HISTORIC AND DESIGN REVIEW COMMISSION

HDRC CASE NO: 2021-135
COMMON NAME: Dawson at N Olive (three individual lots, currently unaddressed)
LEGAL DESCRIPTION: NCB 570 (OLIVE-DAWSON SUBD), BLOCK 6 LOT 23
NCB 570 (OLIVE-DAWSON SUBD), BLOCK 6 LOT 22
NCB 570 (OLIVE-DAWSON SUBD), BLOCK 6 LOT 21
ZONING: RM-4, H
CITY COUNCIL DIST.: 2
DISTRICT: Dignowity Hill Historic District
APPLICANT: Raul Ruiz/OliveDawson LLC
OWNER: Raul Ruiz/OliveDawson LLC
TYPE OF WORK: Conceptual review of new construction
APPLICATION RECEIVED: March 18, 2021
60-DAY REVIEW: Not applicable due to City Council Emergency Orders
CASE MANAGER: Edward Hall

REQUEST:

The applicant is requesting conceptual approval of a site plan for the construction of three (3), 1-story residential structures on the vacant lot at the southwest corner of Dawson and N Olive, located within the Dignowity Hill Historic District. These lots are currently unaddressed.

1 PROPOSED SITE PLAN
Scale: 1/16"=1'-0"

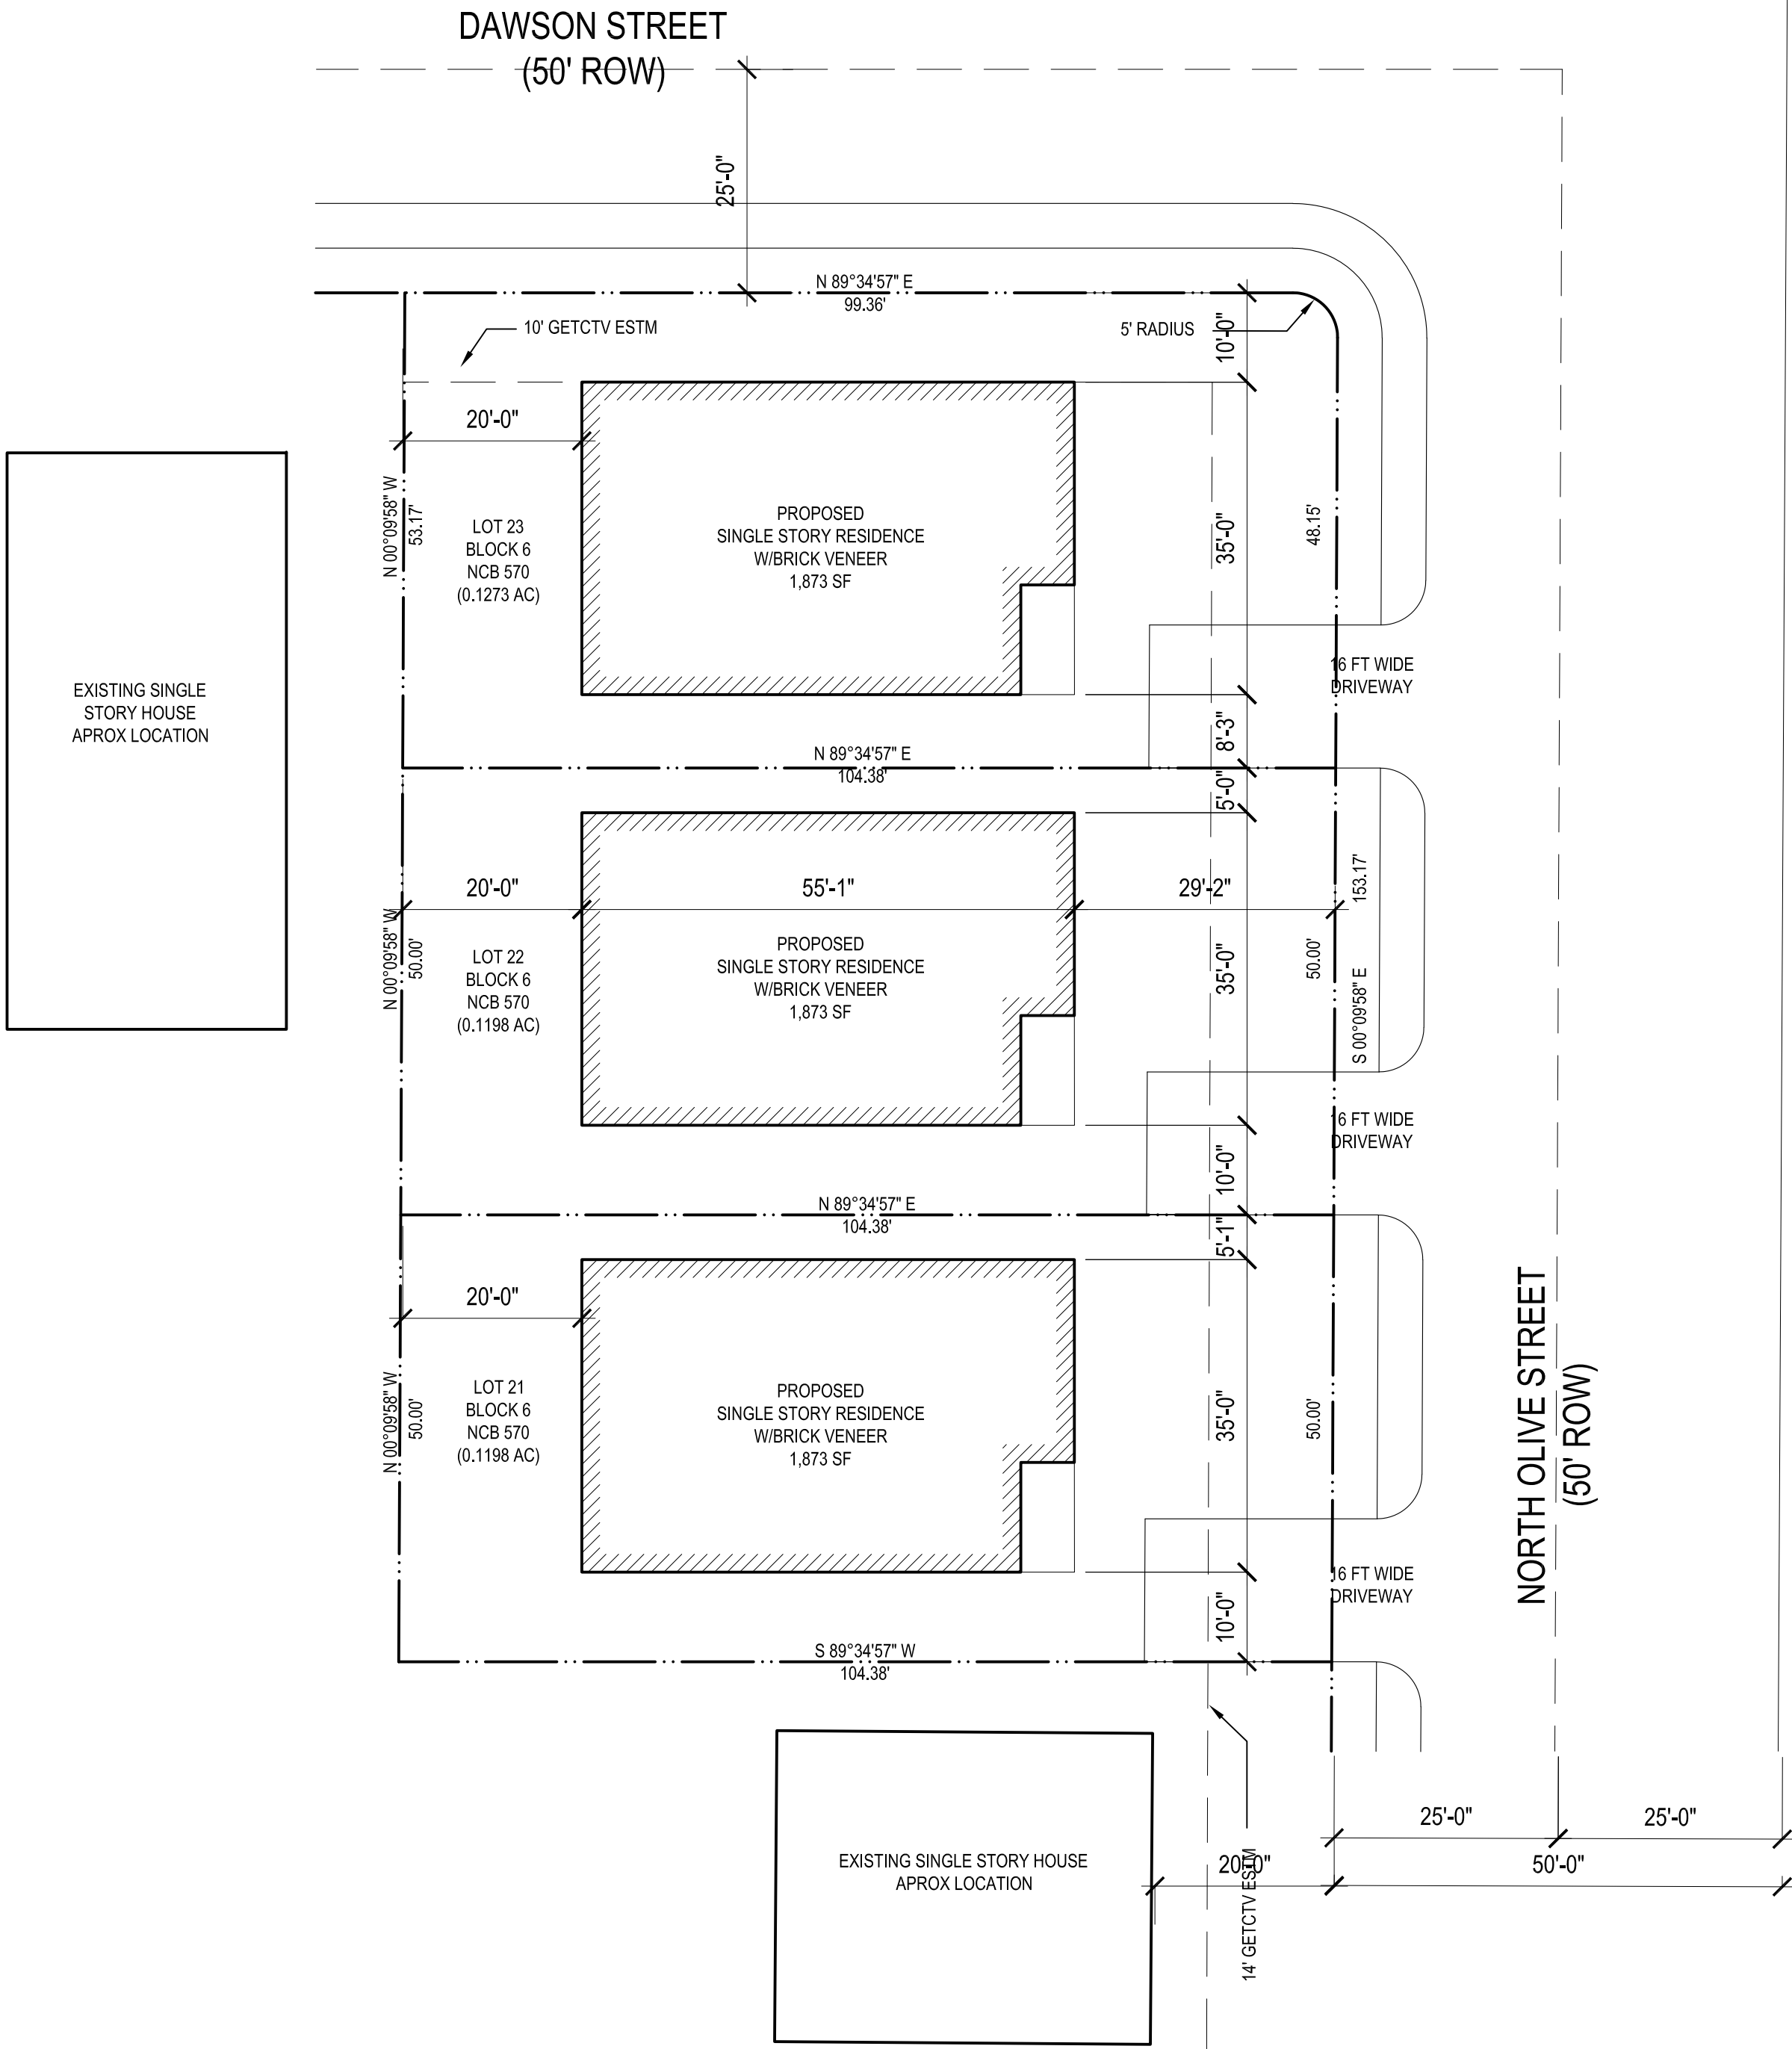
- d. **SETBACKS (N Olive)**– According to the Guidelines for New Construction, the front facades of new buildings are to align with front facades of adjacent buildings where a consistent setback has been established along the street frontage. The applicant has proposed a setback for each structure on N Olive of 29' – 2" from the property line. Per the submitted site plan, the proposed setbacks are greater than that of the adjacent historic structure at 519 N Olive. Generally, staff finds these setbacks to be appropriate and consistent with the Guidelines.

- e. **SETBACKS (Dawson)** – According to the Guidelines for New Construction, the front facades of new buildings are to align with front facades of adjacent buildings where a consistent setback has been established along the street frontage. The applicant has proposed a setback on Dawson of 10' – 0". Per the submitted site plan, the

proposed setback on Dawson Street is less than that of the adjacent historic structure, and is not consistent with the Guidelines for New Construction.

- f. **ORIENTATION (N Olive & Dawson)** – The Guidelines for New Construction note that the orientation of new construction should be oriented consistently with the historic examples found within the district. As noted in finding c, corner structures found historically on Dawson Street feature an orientation toward Dawson. Per the submitted site plan, the applicant has proposed to orient the corner structure toward N Olive, inconsistent with both the Guidelines for New Construction and the historic development pattern within the district. Staff finds that the northern most lot should feature a structure that features a primary orientation toward Dawson Street.

- g. **BUILDING SPACING** – The applicant has proposed approximately thirteen (13) and fifteen (15) feet between each structure. This block of N Olive features building spacing that is less than what is found commonly throughout the district. Staff finds that the applicant should provide additional information noting proposed building spacing that is comparable to that which is found historically on this block of N Olive.

- h. **DRIVEWAYS** – The applicant has proposed driveways which result in front yard parking conditions, which are not consistent with the Guidelines, nor the historic driveway pattern found within the district. Staff finds that driveways should not exceed ten (10) feet in width, and should be positioned at the side of each proposed structure (south side, per the pattern on this block).

- i. **FRONT WALKWAYS** – Historic structures feature walkways that lead from the front porch to the sidewalk at the public right of way. Staff finds that walkways that are consistent with the Guidelines should be added for each structure.

- j. **GENERAL DESIGN** – The applicant has noted on the submitted site plan three structures that feature identical footprints. While many structures within the Dignowity Hill Historic District feature similar footprints, porch design, roof profiles and architectural details, the exact design is not found in a grouped setting. Staff finds that the applicant should incorporate varying massing and architectural details to result in three, unique structures.

Staff does not recommend conceptual approval based on findings a through j. Staff recommends that the applicant address the following items prior to receiving a recommendation for conceptual approval:

- i. That the applicant reorient the structure on the northern most lot to feature an orientation toward Dawson Street and propose a setback on Dawson street that is equal to or greater than those found historically on the block, as noted in findings e and f.

- ii. That the applicant confirm that the proposed building spacing is comparable to that found historically on this block of N Olive, as noted in finding g.

- iii. That the applicant eliminate the proposed driveway configuration which results in front loaded parking as noted in finding h. Staff recommends that the applicant place driveways to the south of the proposed new construction, and that driveways do not exceed ten (10) feet in width.

- iv. That the applicant incorporate front walkways for each structure, as noted in finding i.
- v. That the applicant propose varying massing and architectural details to result in three, unique structures as noted in finding j.

1 PROPOSED SITE PLAN
Scale: 1/16"=1'-0"

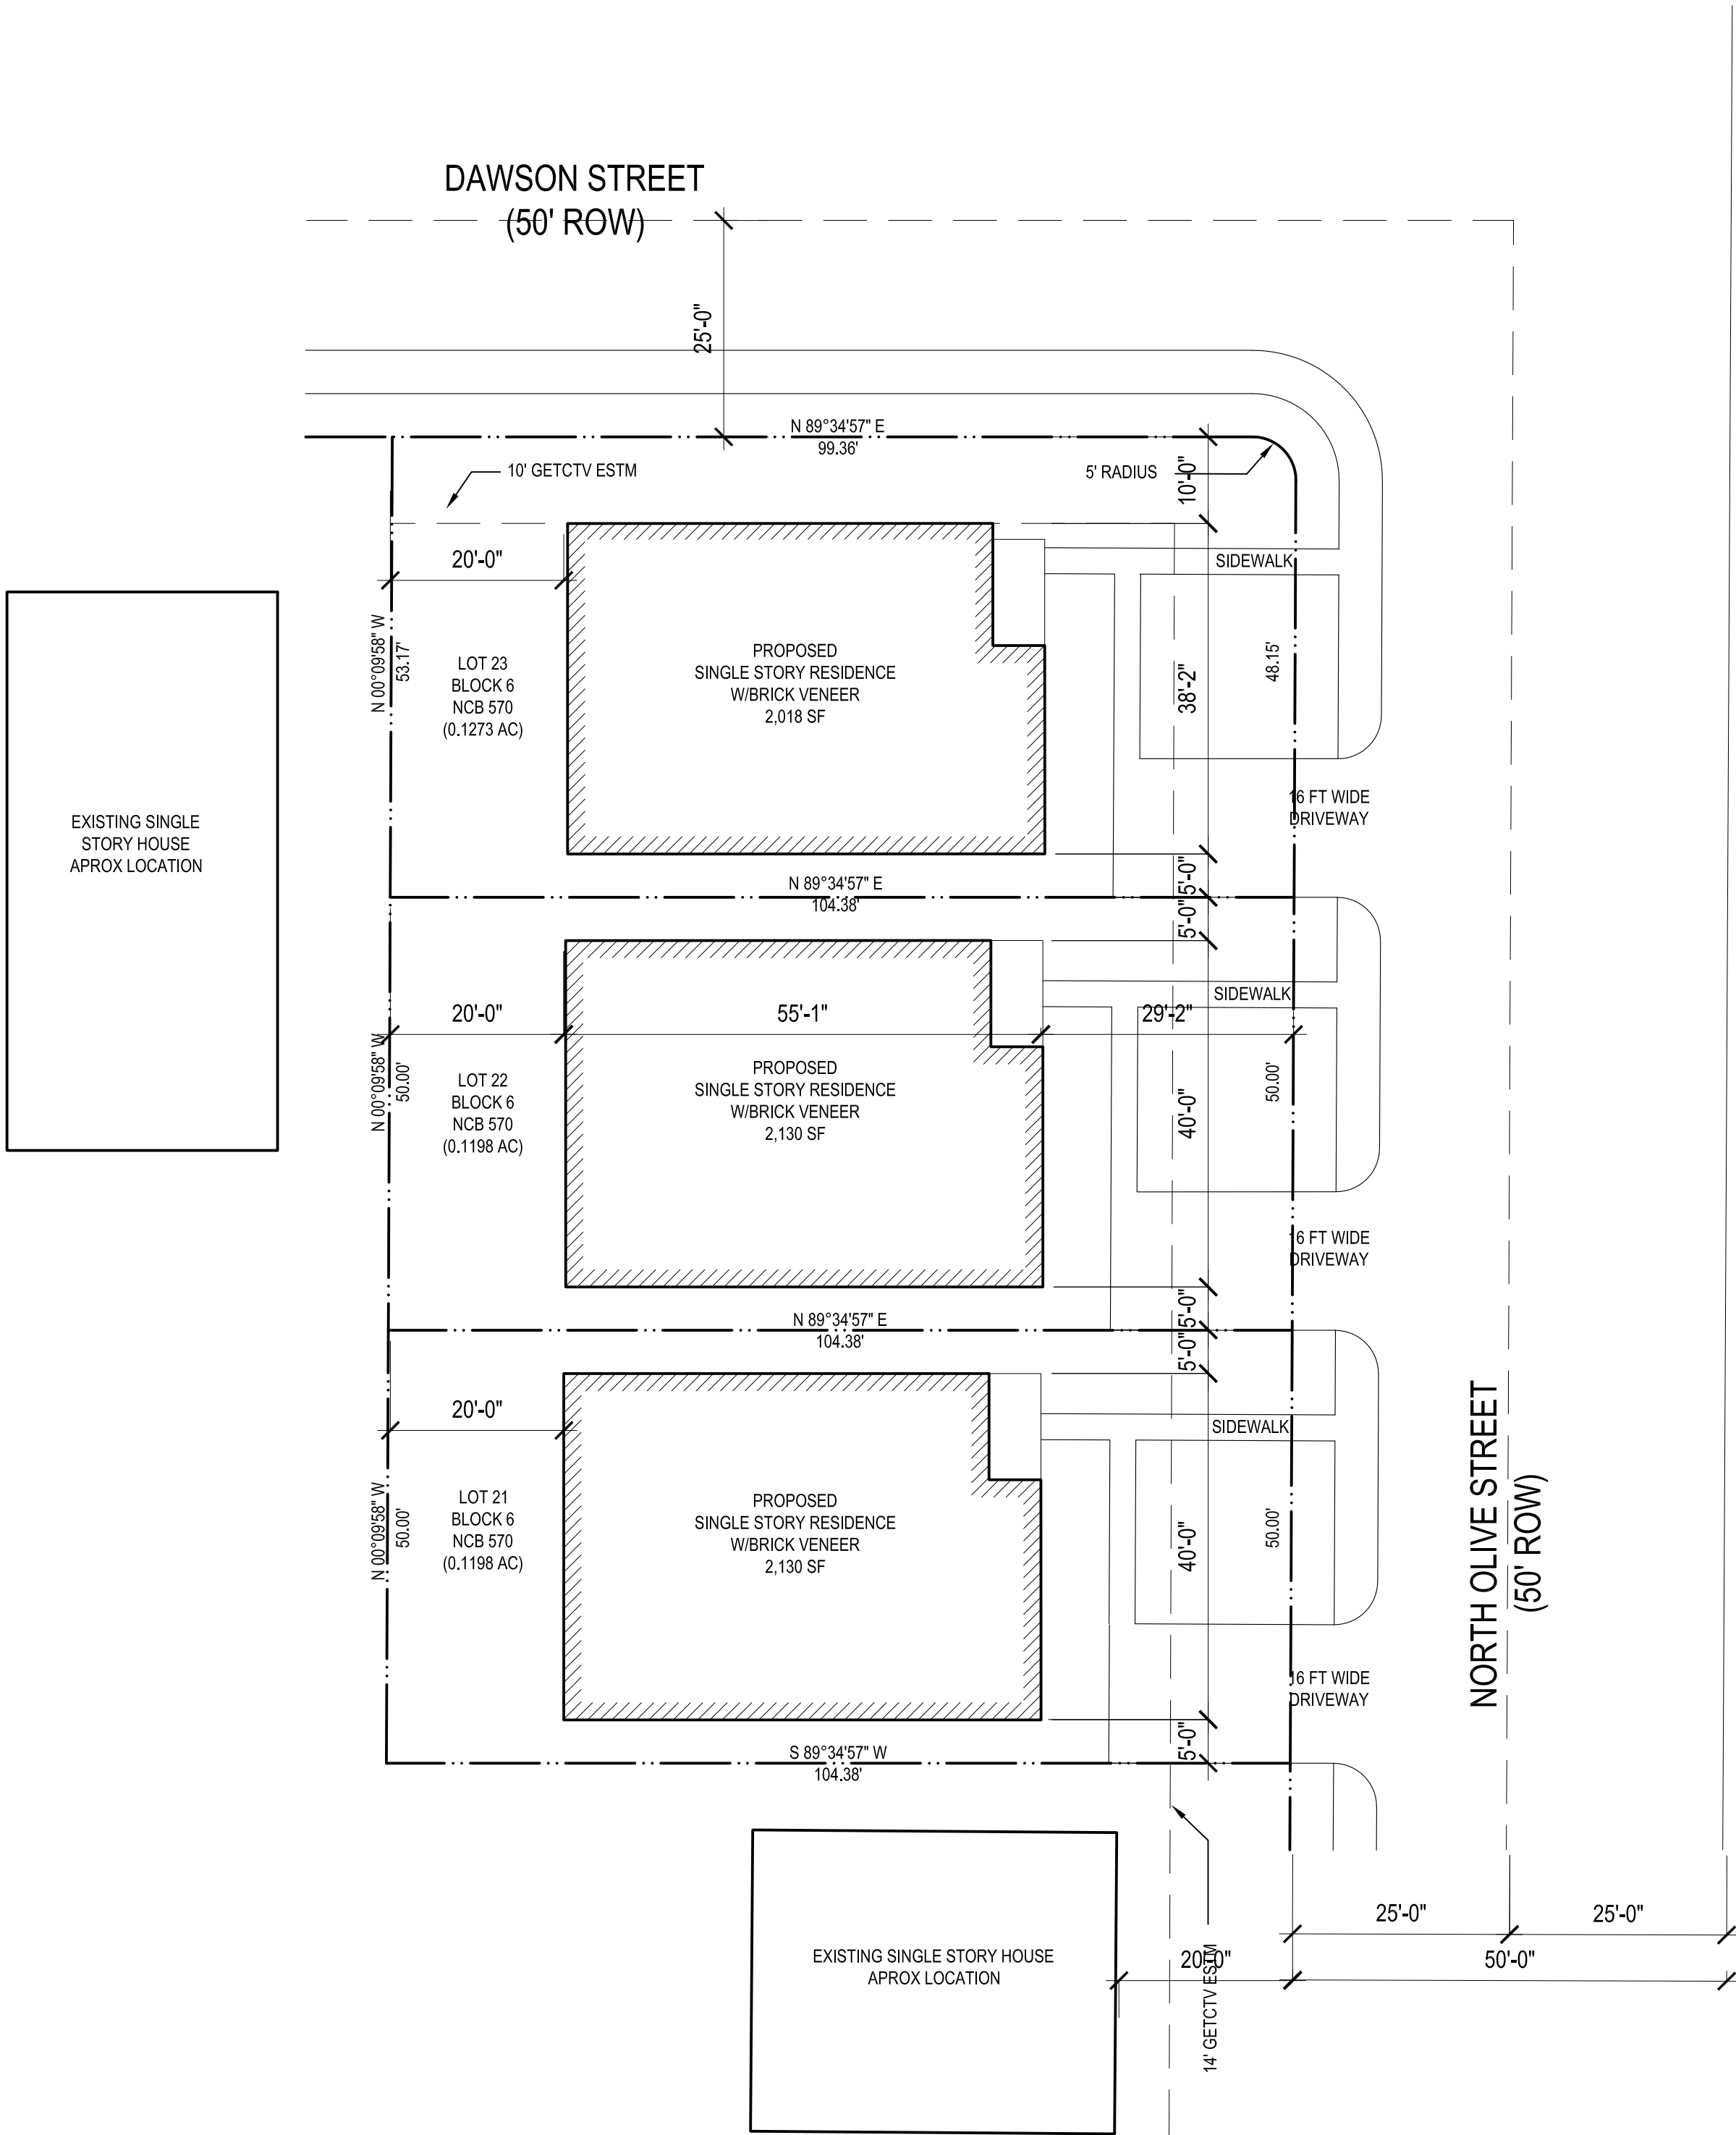
Draw structure all
the way to the
setback line /
